ISO/IEC JTC1/SC2/WG2 N 4377  
Date: 2012-10-24

**Title:** Disposition of comments on SC2 N 4239 (PDAM2.2 text to ISO/IEC 10646 3<sup>rd</sup> edition)

**Source:** Michel Suignard (project editor)

1F6E6 MILITARY AIRPLANE

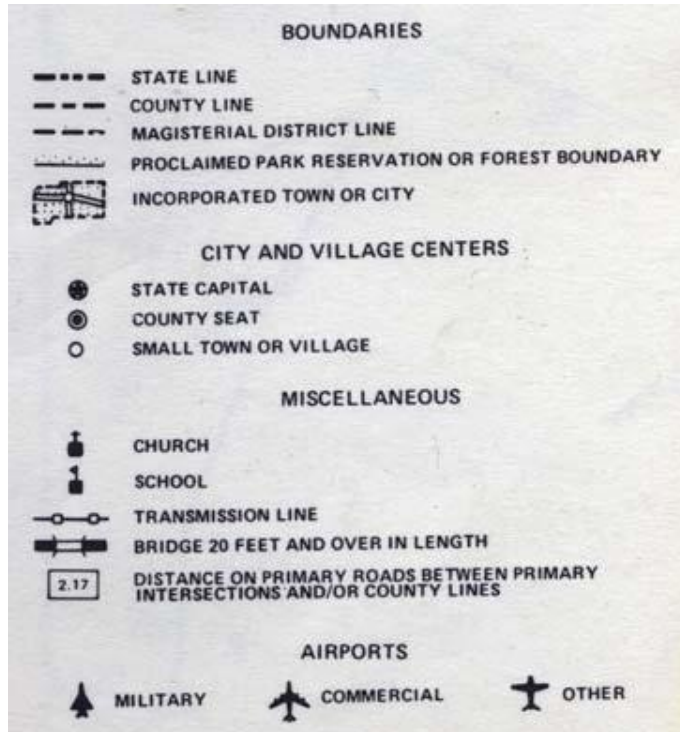
Ireland requests two character additions, along with additional annotations to one character already on the ballot.

The postscript name for 1F6E8 SMALL AIRPLANE is “planesmall”, indicating a kind of small aircraft. the Webdings glyph shown in perspective is hard to identify and too “pictorial”. Further, we have found evidence for the SMALL AIRPLANE character used not only as a Webdings dingbat, but as a Transport and Map symbol used alongside MILITARY AIRPLANE and UP-POINTING AIRPLANE to indicate different kinds of airports.

At the bottom of the legend here three airports, “military”, “commercial” and “other” are indicated with three types of aircraft. The map from which this legend comes is a map of Northampton County published in 1989 by the Virginia Department of Transportation in cooperation with the U.S. Department of Transportation’s Federal Highway Administration.

*Again, concerning the proposed character 1F6E7 (code point in ballot) SMALL AIRPLANE, one should not read too much in the postscript names of Wingdings and Webdings. These names were not publicly available and most users have put these characters in documents expecting the glyphs to stay close to their original design. The expectation when encoding the Webdings and Wingdings characters is to only replace their glyph if the substitution is acceptable when the only change to a document is re-encoding from the original private use area to a regular area. For example, many recent glyph changes have consisted in going from black figures to outlines and resizing.*

*In that aspect the proposed glyph change for the small airplane is too radical. It is preferable to keep the small plane as it is (or at least with minimum changes) and to add another character to complete the requested set to represent the full set shown above.*

*This results in three additions:*

*1F6E6 UP-POINTING MILITARY AIRPLANE*

*1F6E7 UP-POINTING AIRPLANE*

*1F6E8 UP-POINTING SMALL AIRPLANE*

*In addition the previously proposed SMALL AIRPLANE is moved to 1F6E9.*

## **TE.8. Changes in glyphs from black to white in Pdam2.2**

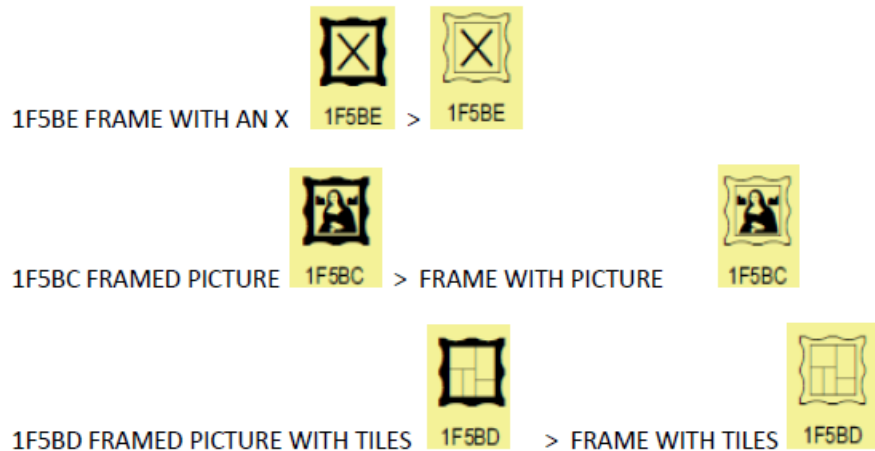
In several cases the change from "black" to "white" makes the symbol less recognizable and the change does not seem to be motivated. We suggest that the original glyph be restored (/revised, if applicable – see comments below).

Based on the General comment above, we recommend all picture frame glyphs be reverted to the earlier glyphs.

### Accepted
